ENVIRONMENTAL COMMISSION RECOMMENDATION 20240515-004

Subject: Sunfield PUD Amendment #1, C814-2014-0083.01

NAME & NUMBER OF PROJECT: Case No. C814-2014-0083.01; Sunfield PUD Amendment #1

REQUEST: To amend a Planned Unit Development (PUD)

Environmental Exhibit

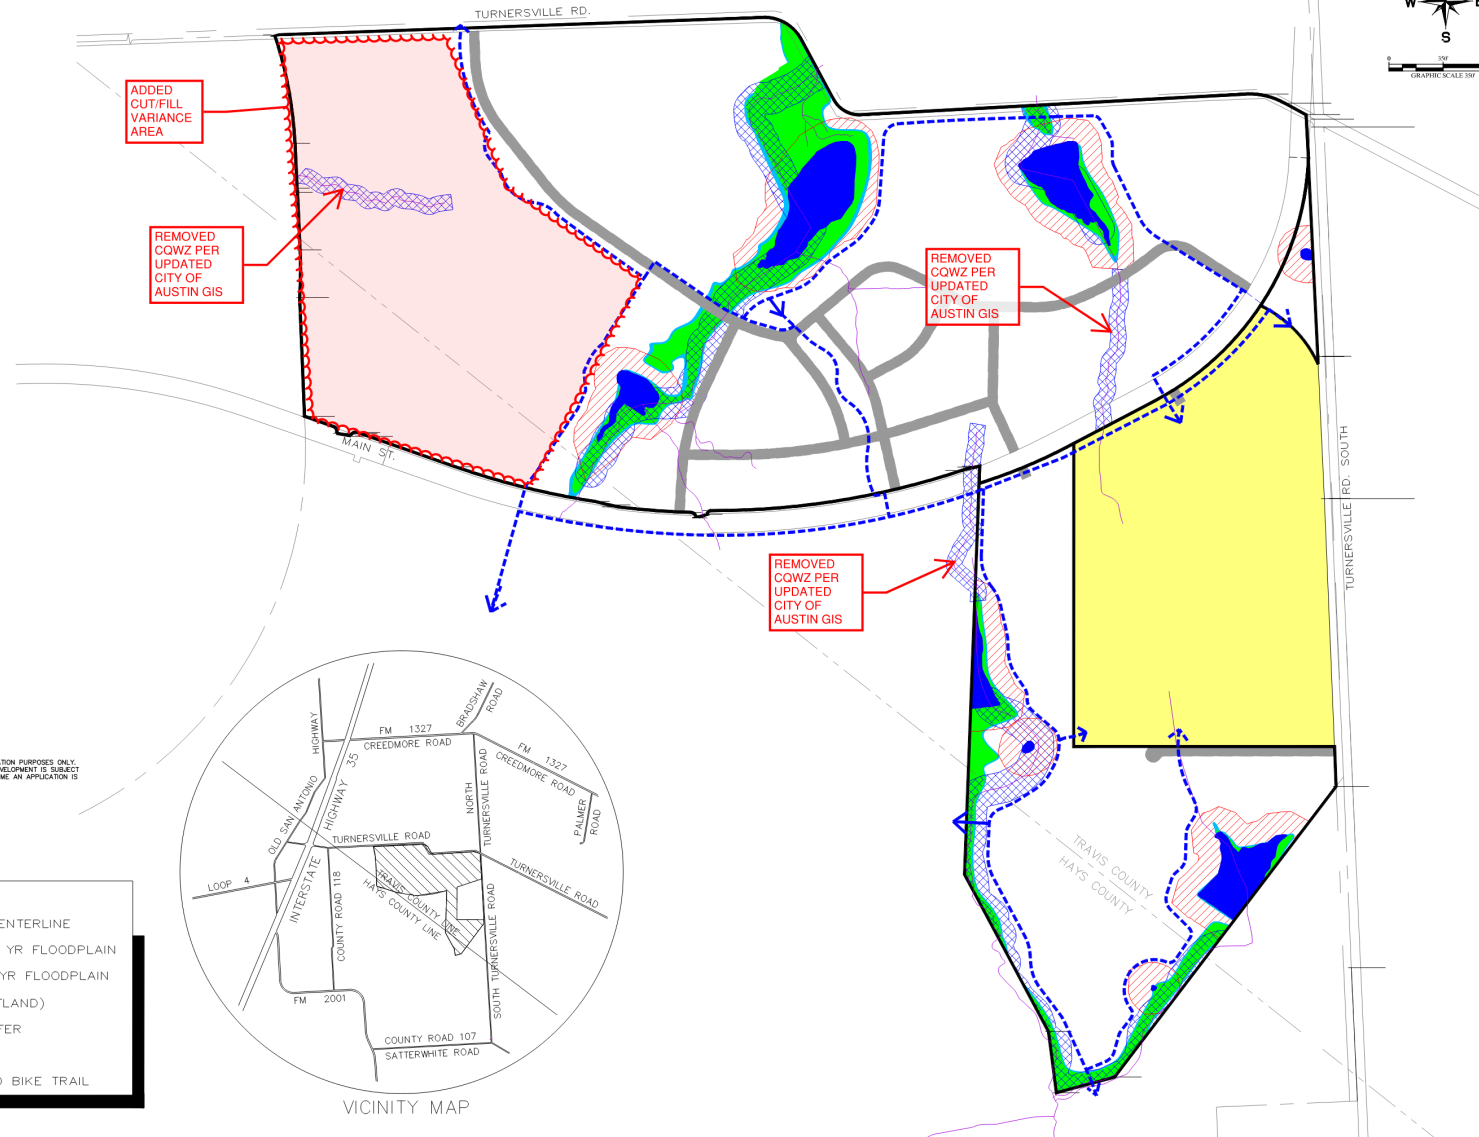
- 1. Section 25-8-341 modified to allow cut to exceed 4 feet (up to 20 ft) to allow for the construction within the area shown on Environmental Exhibit**
- 2. Section 25-8-342 modified to allow fill to exceed 4 feet (up to 20 ft) to allow for the construction within the area shown on Environmental Exhibit**
- 3. Modify Land use from Residential to Commercial/Industrial. Increase in allowable IC from 57.87% to 62.33% (21.484 acres)**
- 4. Remove +1000 linear ft of previously unprotected creek**

Staff recommends approval of the PUD Amendment with the following conditions:

- 3. The project will require 10% more trees than minimally required by the current PUD ordinance and current code regulations.**
- 4. The project will provide enhanced stabilization measures including terracing and retaining walls for areas exceeding 8 feet of cut or fill.**
